EEE LPI Signaling

Contribution to IEEE 802.3cy

May 24, 2022

Figure 165–20—EEE transmit state diagram

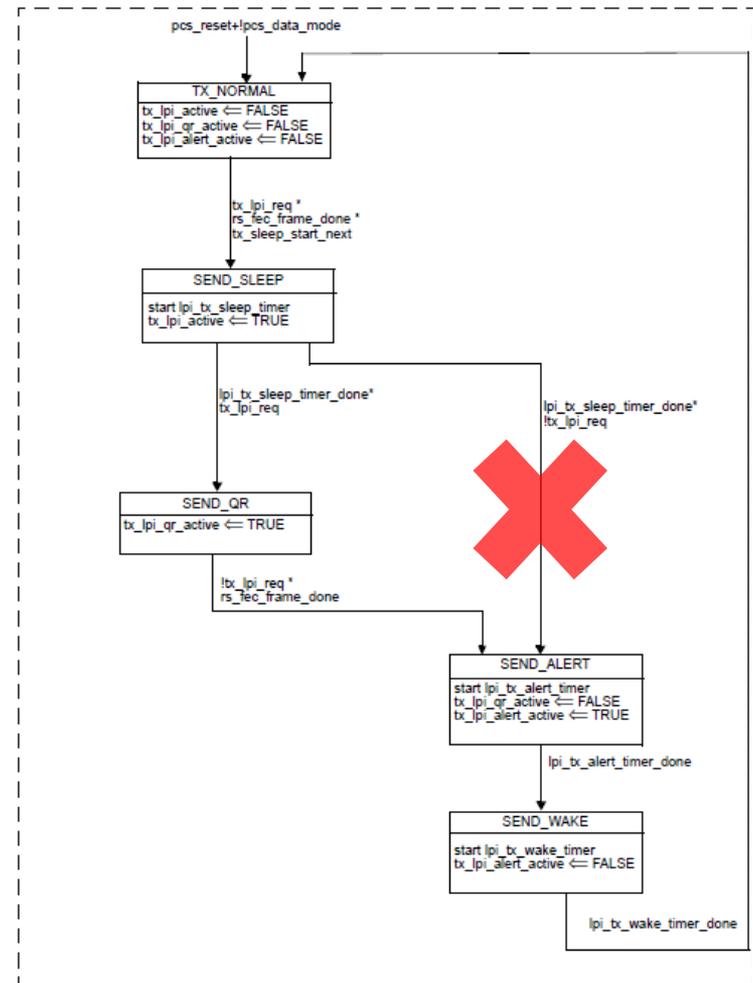
- Because of frame alignment constraints, the SEND_SLEEP state can never transition straight into SEND_ALERT

- Update figure 165-20 to eliminate transition from SEND_SLEEP to SEND_ALERT
- In the path from SEND_SLEEP to SEND_QR, change “lpi_tx_sleep_timer_done*tx_lpi_req” to “lpi_tx_sleep_timer_done”

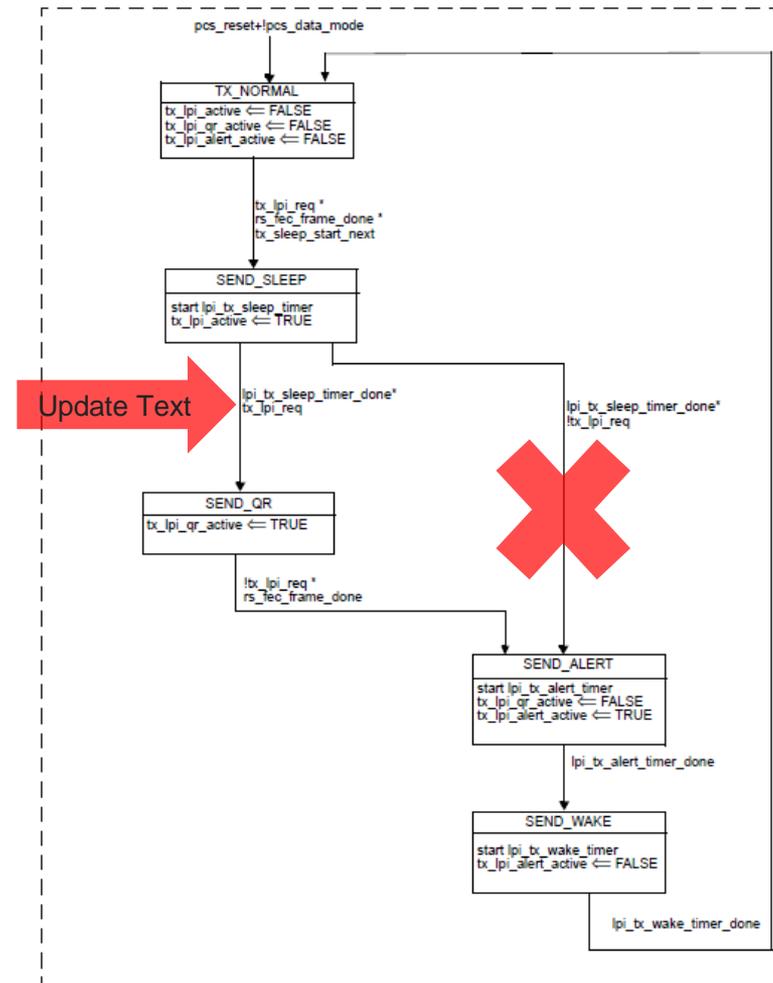
~~The start of the SLAVE quiet-refresh cycle is delayed from the MASTER by lpi_offset. The MASTER and SLAVE alert windows are offset from each other and the refresh periods are close to half a cycle offset.~~

Following the transition to PAM4, the PCS continues with the RS-FEC frame count and uses the count to generate refresh, alert, and wake control signals for the transmit functions.

Alert, a four RS-FEC frame long sequence (alert_length), shall **start four frames after** at the beginning of any eighth PHY frame boundary **counting from the start of the QR cycle** starting at the beginning of the frame following a refresh PHY frame. This offsets the MASTER and SLAVE alert start times by alert_period/2 and provides two benefits. The first benefit is that alert transmissions do not overlap with the device's own refresh. The second benefit is that the MASTER and SLAVE alert transmissions generally do not overlap, and only overlap at the limits of tolerances. The MASTER and SLAVE shall derive the tx_refresh_active and tx_alert_start_next signals from the transmitted PHY frames as shown in Table 165–5 and Table 165–6. When Slow Wake is active, alert can be transmitted in only a single QR cycle location, **stating at frame 92.**
